Supplement 2 to Dresden Station Special Report No. 14

Quad-Cities Station Special Report No. 7

"RESPONSE TO AEC QUESTIONS CONCERNING THE PROPOSED

CONTAINMENT ATMOSPHERIC DILUTION SYSTEM"

FIGURE 3. DRESDEN 2, 3 – CONTAINMENT PRESSURE AS A FUNCTION OF TIME FOLLOWING LOCA WITH DILUTION (MAXIMUM NITROGEN ADDED PER FIGURE 2)

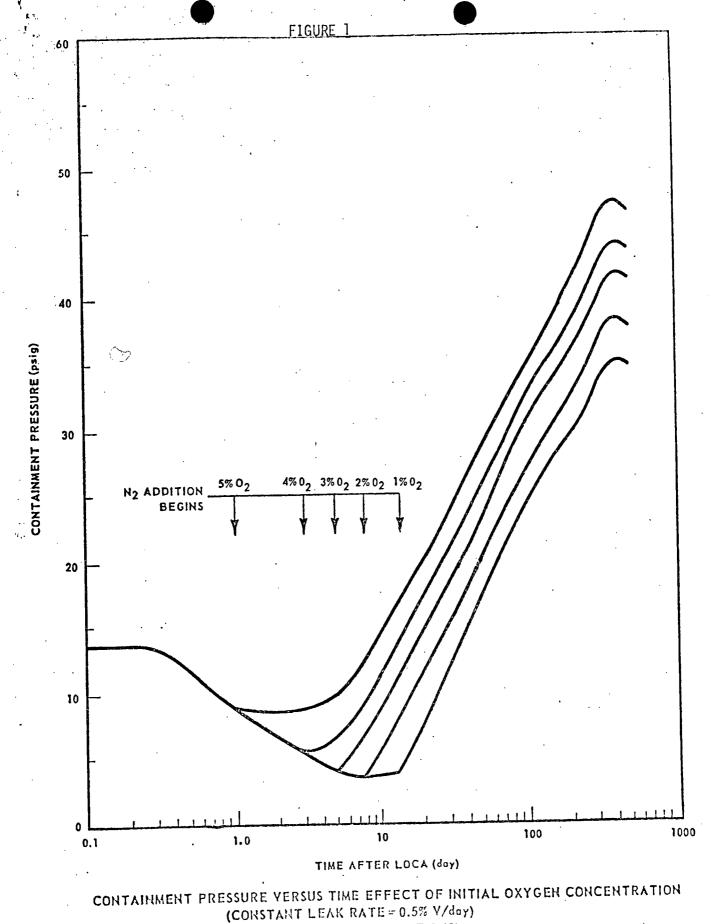
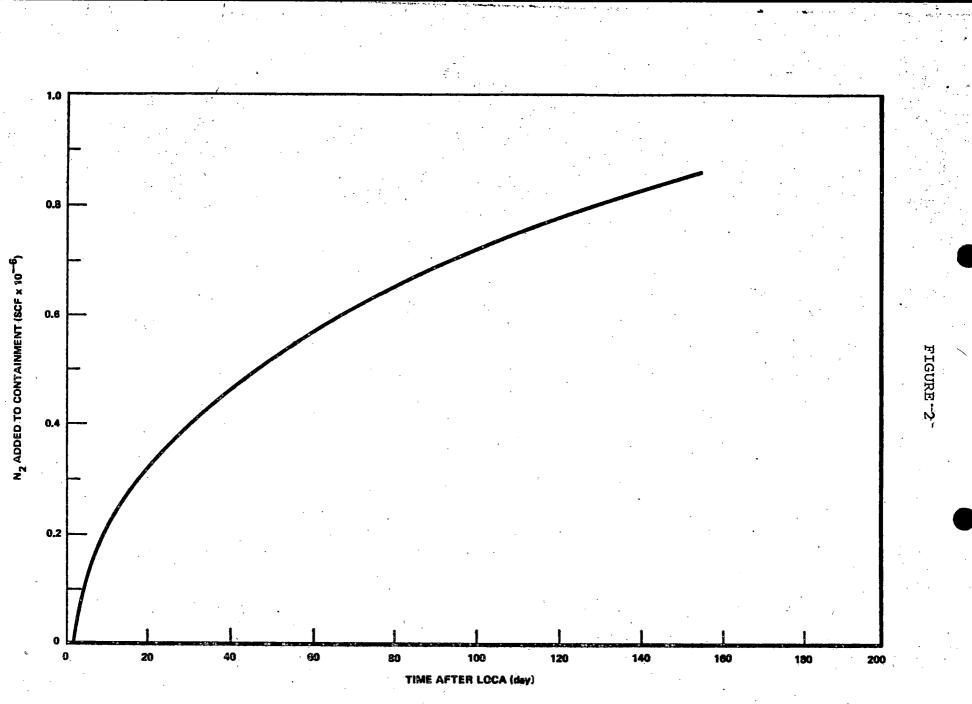
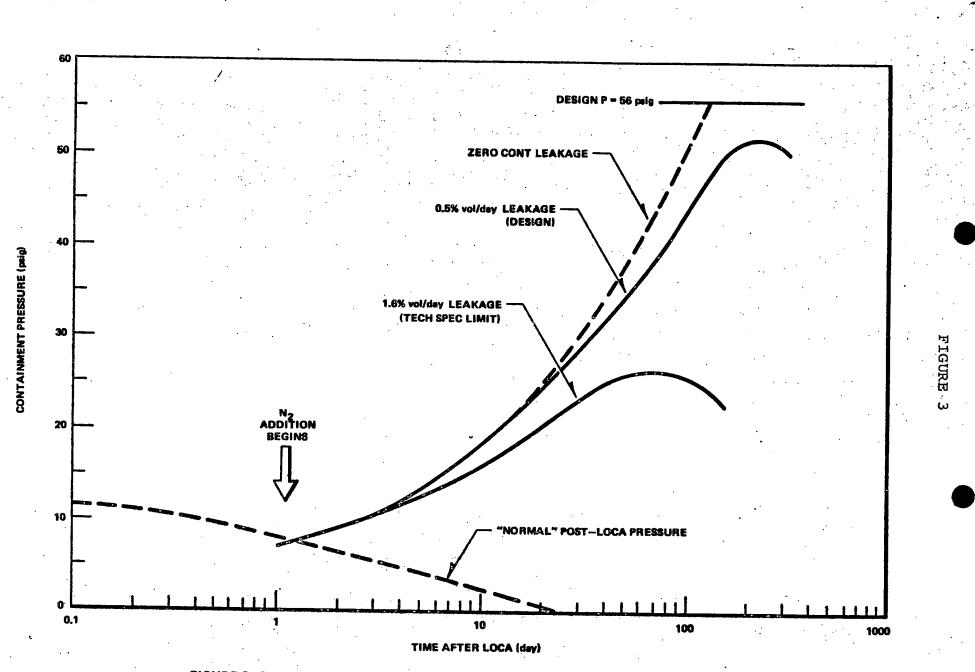
Present an analysis of the time at which nitrogen addition must begin following a LOCA as a function of initial oxygen concentration.

Figure No. 1 represents a generic function of containment pressure versus time (for different oxygen concentrations). Figures No. 2 and No. 3 demonstrate the somewhat higher pressures characteristic of Dresden and Quad-Cities (see Dresden Unit 3 Supplement to Special Report No. 14).

Percent Water Vapor Versus Time O% Leakage - N₂ Injection FIGURE 2-G.1-2

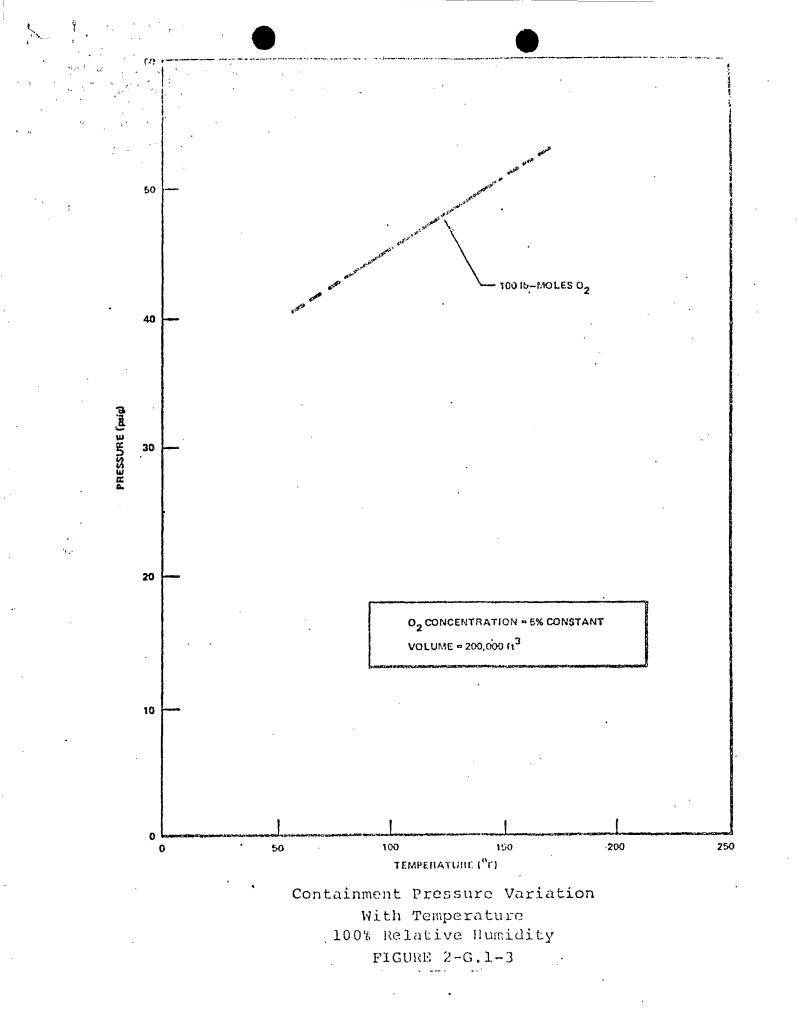
> f. The analysis of combustible gas buildup assumes dilution by steam during the post-LOCA period. Provide tables or curves of steam concentration versus time assumed for your calculations. State the bases and assumptions used for long-term pressure transient calculations in each sub-volume. Justify that the long-term pressure transient calculations are conservative from the viewpoint of steam concentration and nitrogen makeup required.

The range of steam concentrations can vary from 100% in the drywell immediately following the blowdown down to practically zero. Choosing the zero leakage case for illustration, Figure 2-G.1-2 shows the steam concentration vs time in the drywell-and suppression chamber following the LOCA.

Maximum Hydrogen and Oxygen Concentration Gradients In Suppression Chamber FIGURE 2-G.1-1

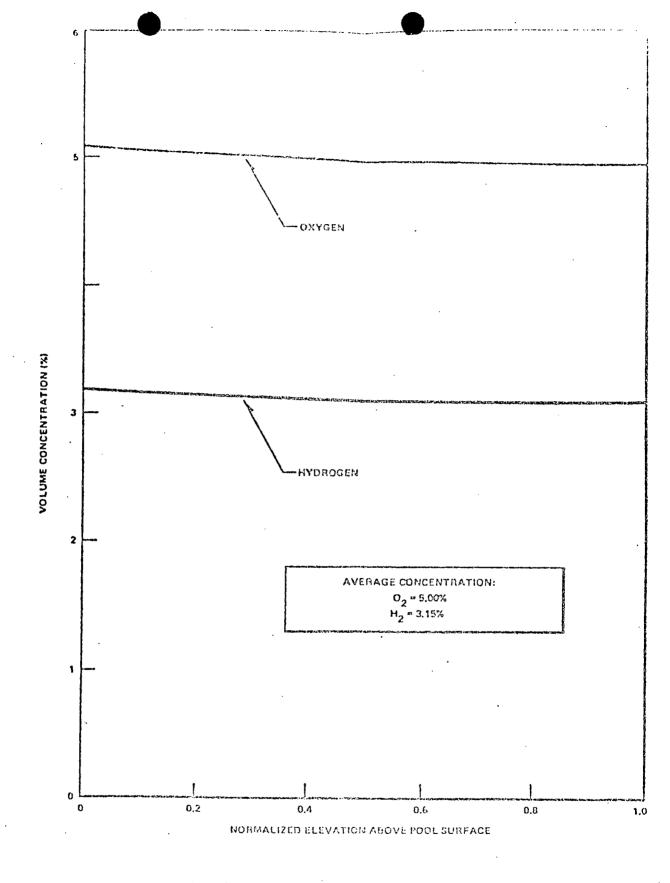
> Provide the assumptions and the precise diffusion calculations describing atmospheric mixing in _containment.

This mass/heat transfer analogy was used to make a conservative prediction of the concentration gradients for oxygen and hydrogen in the suppression chamber. The results of this analysis are summarized in Figure 2-G.1-1. It shows a maximum oxygen concentration of 5.10% at the suppression pool surface for an average concentration of 5%. Because of its higher diffusivity, the concentration gradients for hydrogen are even less. Using less conservative assumptions with respect to natural convection, heat transfer coefficients would result in a maximum oxygen concentration of only 5.015% at the pool surface:

Using these values for Kt in the Carslaw and Jaeger solution $\frac{1}{k^2}$ (constant flux) resulted in the concentration gradients shown in Figure 2-Gl.1-1. It should be noted here that only that portion of the total oxygen concentration which was due to radiolysis (about 30%) was subject to the gradient calculation. The remaining oxygen was part of the original inventory, hence it does not have a gradient associated with it. All of the hydrogen was assumed to be subject to the gradient, even though a small part of it was from the hydrogen due to the metal-water reaction.

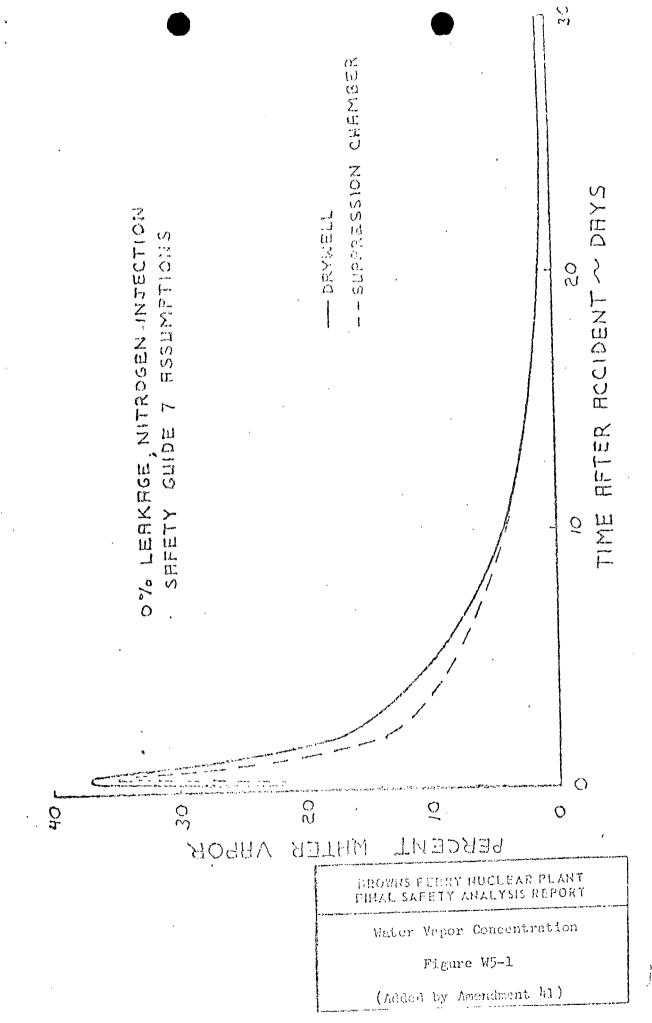
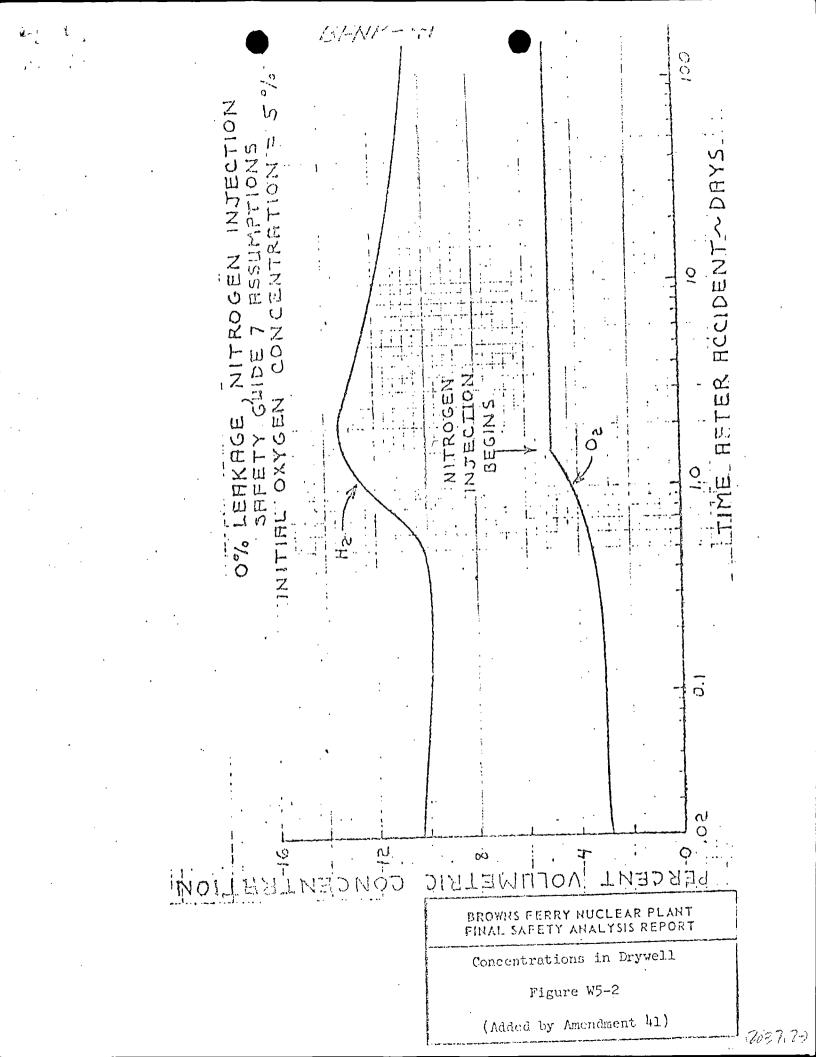
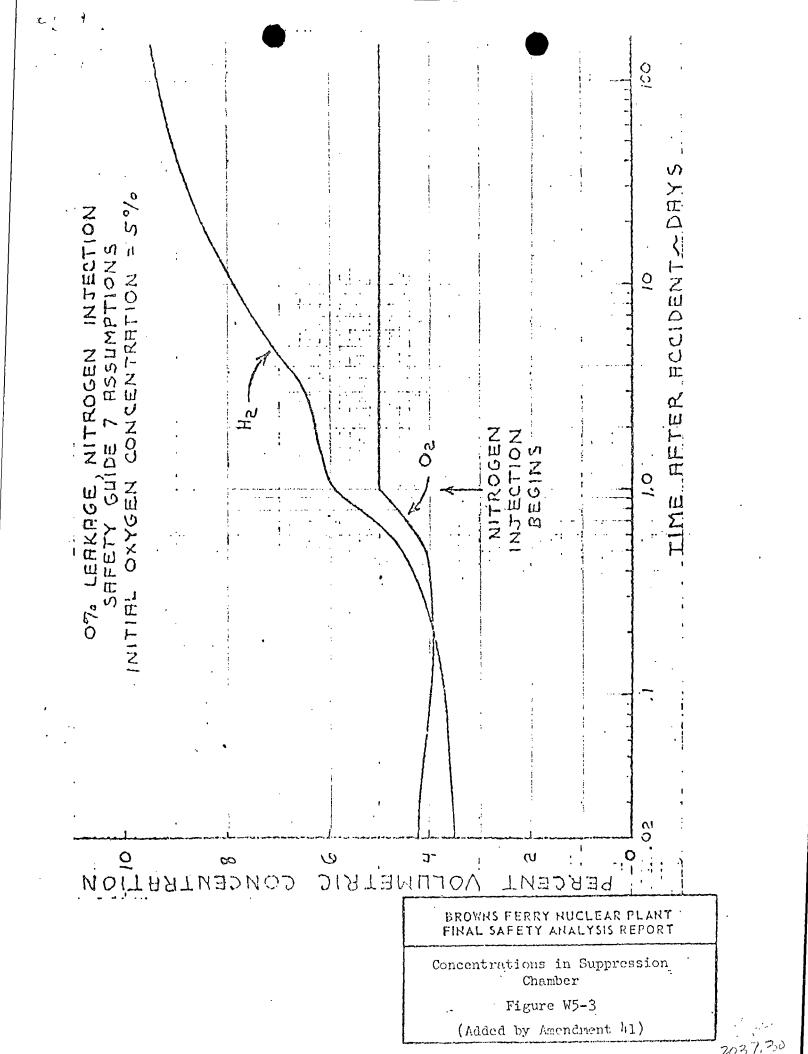
Using Safety Guide No. 7 parameters, provide curves of the oxygen and hydrogen gas generation versus time for the suppression chamber and for the drywell. Provide the steam concentration for each location versus time and indicate the point in time when homogeneity of the gases occur. Distinguish between core and containment solution radiolysis.

The BFNP curves of hydrogen, oxygen and steam concentration in the drywell and suppression chamber are attached as representative of Dresden and Quad-Cities. (Figures W5-1 through W5-3). No attempt is made to predict when homogeneity occurs. The maximum deviations in oxygen concentration were discussed in the response to Question No. 5 above and were found to be very small considering just diffusion and natural convection as the mixing forces. Therefore, for all practical purposes, homogeneity can be assumed at any point in time.

The curve showing water vapor content in the drywell and suppression chamber is based on maximizing the pressure in the containment $(90^{\circ}F$ cooling water, $90^{\circ}F$ initial suppression pool temperature, and no containment sprays operating). The effects of cold containment conditions are discussed in the response to Question No. 4 above.
